SEABROOK STATION
Engineering Office

SBN- 928
T.F. B7.1.2

Subject: Revisions to FSAR Section 8.2 - Off-Site Power System

Revised FSAR Section 8.2 Excerpts

FIGURE 8.2-11A

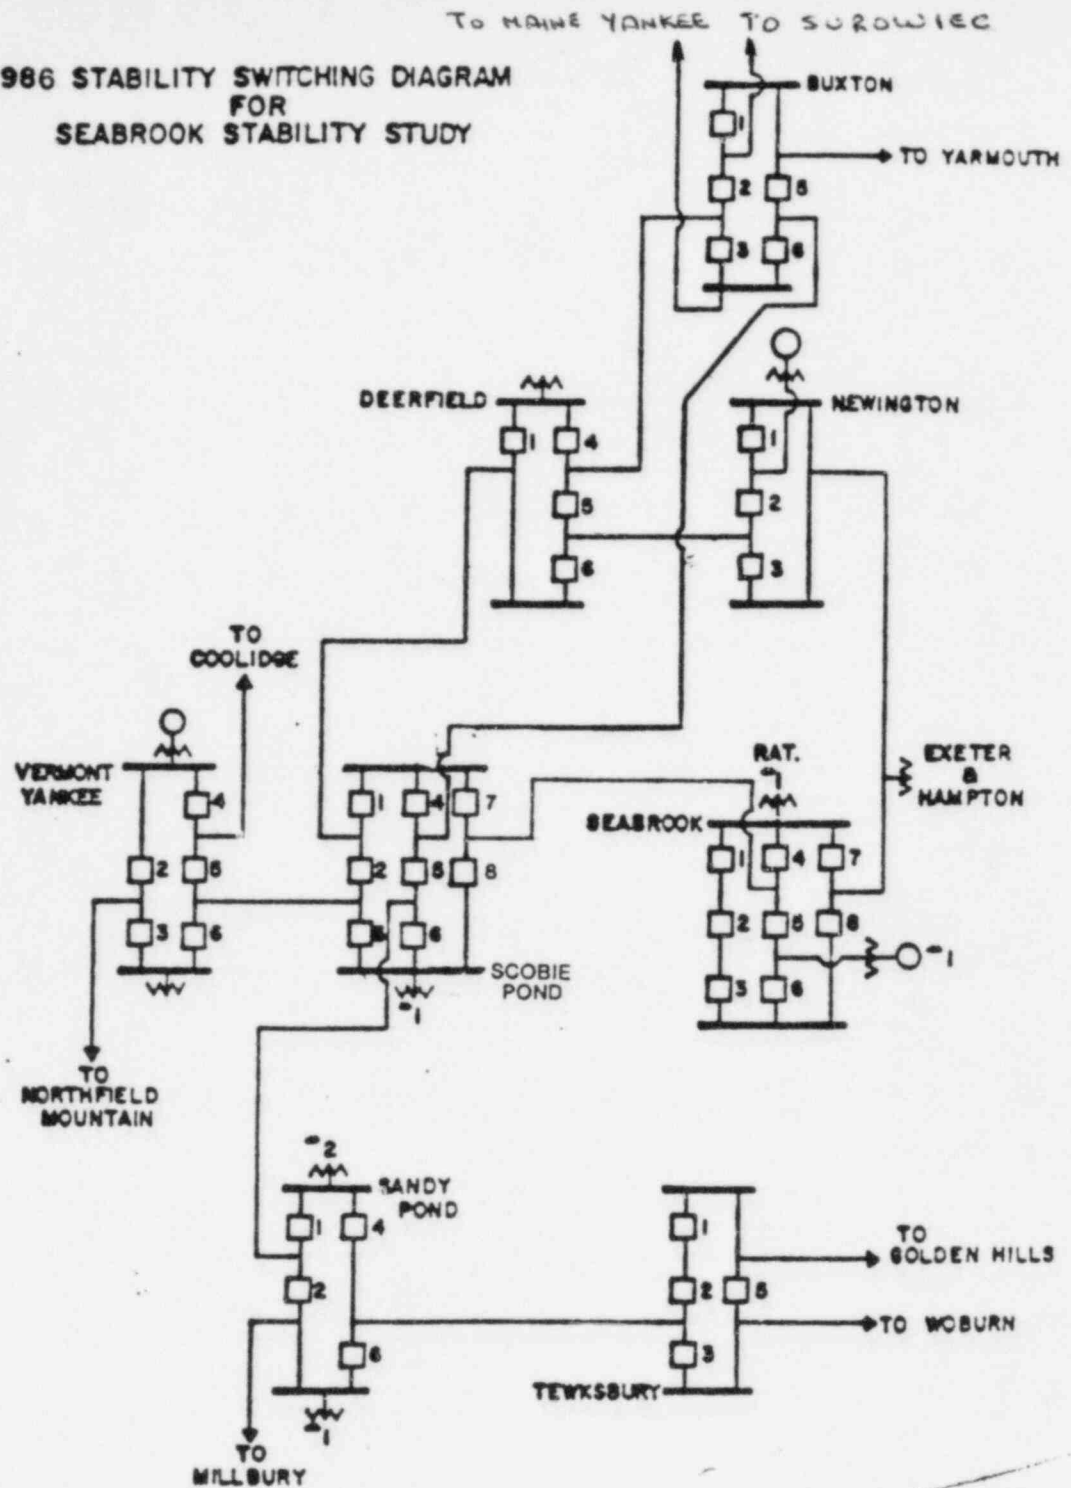
Thermal transfer limits as determined by NEPLAN were taken into consideration for this time period assuming the Seabrook-Tewksbury line is not in service. Stability testing was done at these transfer limits as discussed in Reference 13. Several different generation dispatches were tested to determine how these different dispatches effect system performance.

Figure 8.2-11A represents the switching diagram of the portion of the 345 kV transmission system most closely tied to Seabrook for this particular study.

These studies have demonstrated that Seabrook Unit 1 connected to the transmission system by two 345 kV lines (Seabrook-Scobie Pond and Seabrook-Newington) can meet the NEPOOL "Reliability Standards for the New England Power Pool" and the NPCC "Basic Criteria for Design and Operation of Interconnected Power Systems."

Furthermore, load flow studies performed demonstrate the power system can be operated such that loss of the Seabrook to Scobie Pond line, Seabrook to Newington 345kV line or for other representative line contingencies, all voltages and line loadings can be within required limits.
